Executive Order G-70-38-A

Relating to the Modification of the Certification of
the Texaco Balance
Phase II Vapor Recovery System

Executive Order G-70-38-A
Texaco Balance Phase II
Vapor Recovery System

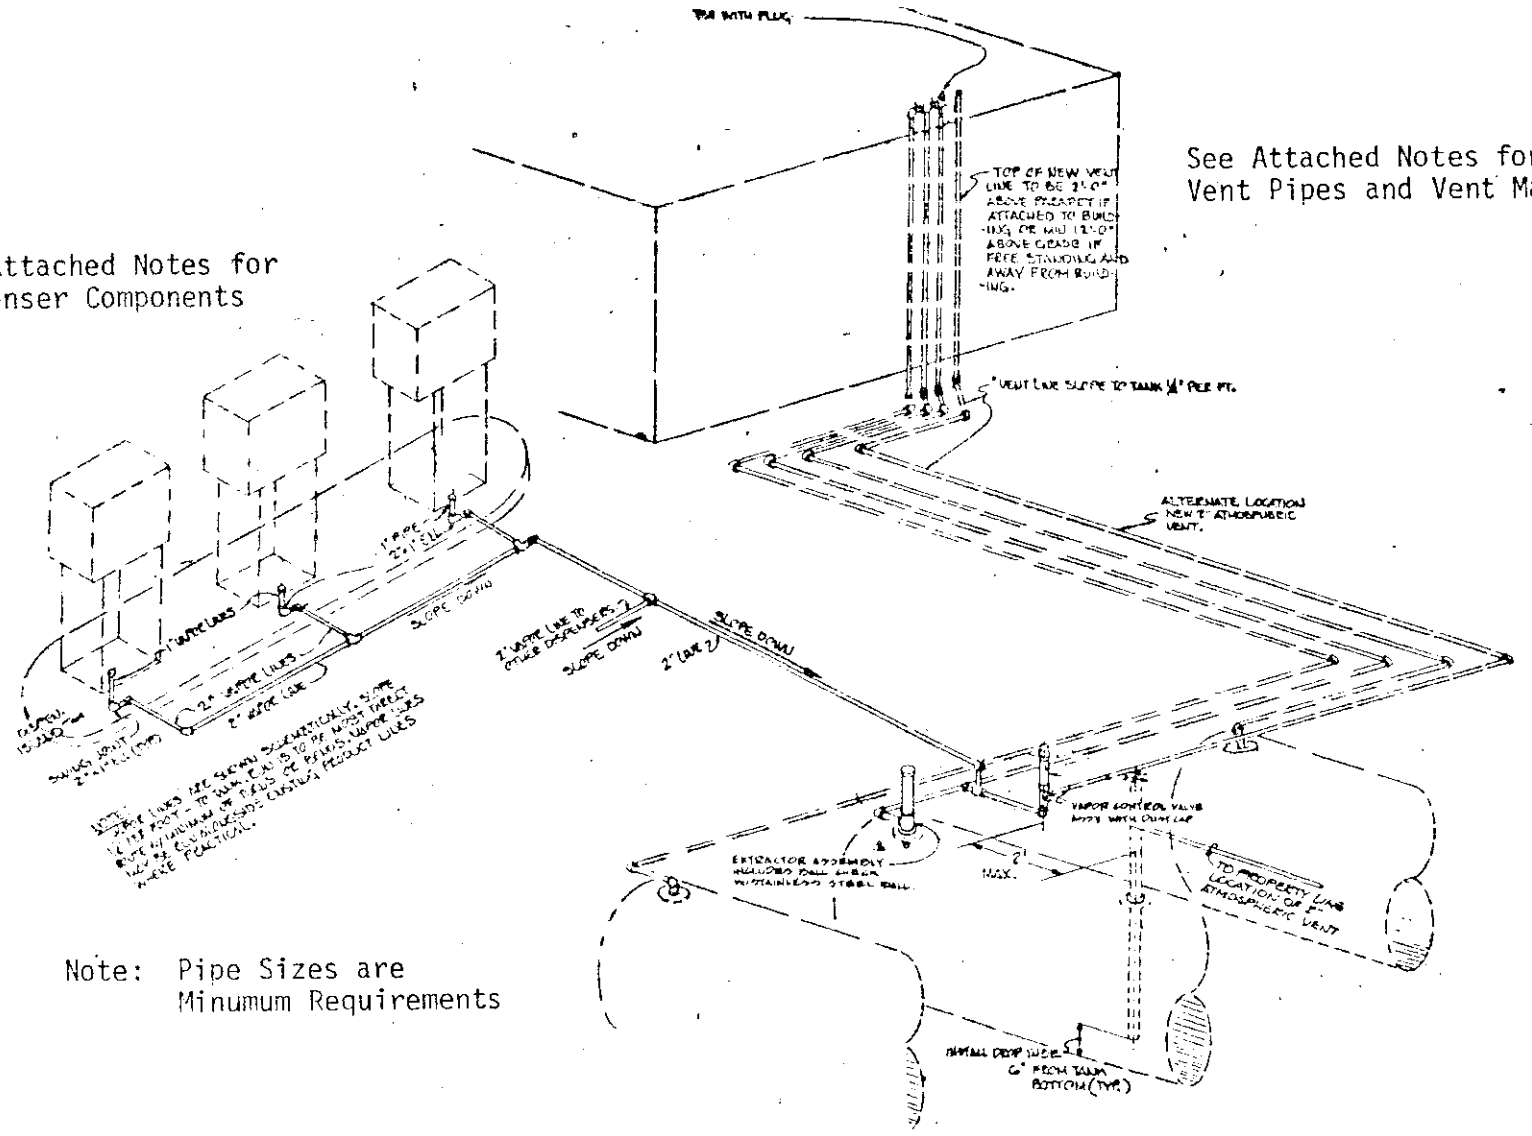
IT IS ORDERED AND RESOLVED: That the certification, Executive Order G-70-38, issued May 18, 1979 for the Texaco balance Phase II vapor collection and disposal system is hereby modified to eliminate the previously allowed use of a single OPW 78 series recirculation trap on dual dispensers dispensing the same product from both sides. The system hereby modified is certified to be at least 95% effective in the self-serve and/or attendant use at gasoline service stations in conjunction with the Texaco Phase I vapor recovery system which has been certified by the Air Resources Board in Executive Order G-70-20. The piping arrangement for the system hereby certified is described in Exhibit I attached. A listing of certified system components is hereby presented in Exhibit 2 attached hereto.

~~11. On dual dispensers dispensing the same product from both sides, the vapor return lines may be connected to a single OPW 78 series recirculation trap mounted internally in the dispenser.~~

Maximum Pressure Drop Through the System*
(Includes Nozzle, Vapor Hose, *Swivels*, *Recirculation Trap*, and Underground Piping)

Flow (CFH)	Δ("H_2O)
20	~~0.10~~ *less than 0.15*
60	~~0.40~~ *less than 0.45*
100	~~0.90~~ *less than 0.95*

11. For those dispensers classified as non-commercial by the Division of Measurement Standards and are not required to be tested and sealed by Weights and Measures officials, the use of recirculation traps is optional. However, the use of recirculation traps is recommended by the Division of Measurement Standards in any installation where the user utilizes the gallonage figures.
